City of Charlottesville

Board of Architectural Review

May 16, 2023, 5:30 p.m.

BAR # 23-05-03

PROPOSED SITE PLAN

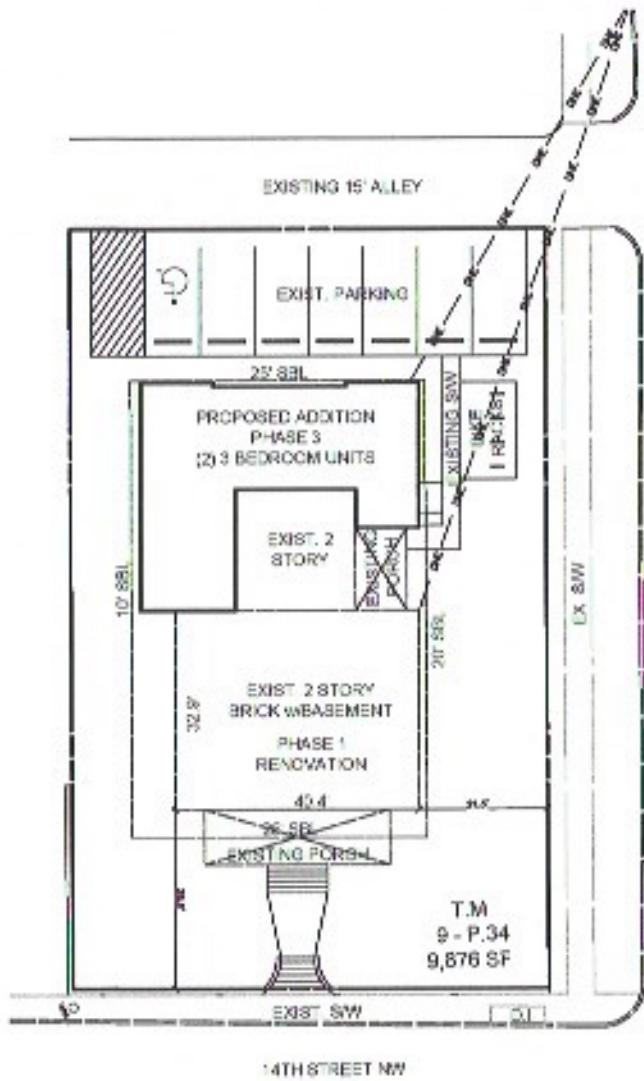
Mr. Schwarz – I am looking at your existing and proposed landscape plans. On the new plan, you have on the back corner an 18 inch black locust remain that doesn't show on the existing plan. Was that a mistake?

Mr. Wassenaar – In the phase III work, it would be demolished. It is a nice tree and one of the few trees that has any redeeming value. Unfortunately, it doesn't fit with the development plan that works in the fully developed phase. We would put in other trees to fill in that part.

**BRICK**GENERAL SHALE -
OLD ENGLISH TUDOR**SIDING**

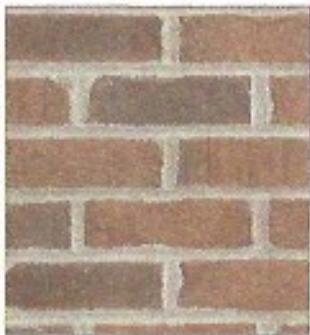
Mr. Schwarz – My one concern is the change in colors. It is obviously going to be new construction. Even the brick will obviously be new brick. You are just continuing the roofline. I know our guidelines are picky about breaking the roofline. You are recessing the roofline. I am not sure the change in colors was necessary.

Mr. Gastinger – I feel it is impossible to evaluate the brick with the perspectives. Relative to color, they're washed out. It is hard to tell. We know, from the existing photos, that is a really rich, red brick. Seeing the two photos of a brick panel against existing, I can be swayed either way. The project is very straightforward and appropriate for the context. It just needs a little more detail, seeing the landscape plan, and some clarity about the brick intentions.

Mr. Wassenaar – We have dealt with this with the National Park Service guidelines on not trying to emulate or duplicate the color of the existing brick. The general rule is that we want shift the color enough that it looks different when you see it in various light conditions. That's the goal. I think we did that. If there's a question about that, we can certainly refine the design intent. The samples that we provided to you do that relative to the existing brick color. We just got a new color rendering that is going to give us a better ability to match the brick colors without having a problem with that. It's been hard to get those exactly right because of the lighting and the variation of the existing brick that has aged on the existing house. The design intent is that it be a contrasting red brick that is different from the front house brick.

Mr. Wassenaar – That's a subjective comment. I am hoping to consider the Park Guidelines to lead us in the direction of doing something that is contrasting so you don't mistake the old with the new. This is such a small building on an intimate scale. If you want us to match, we can certainly do that. The shifts in the rooflines are enough along with the difference in construction.
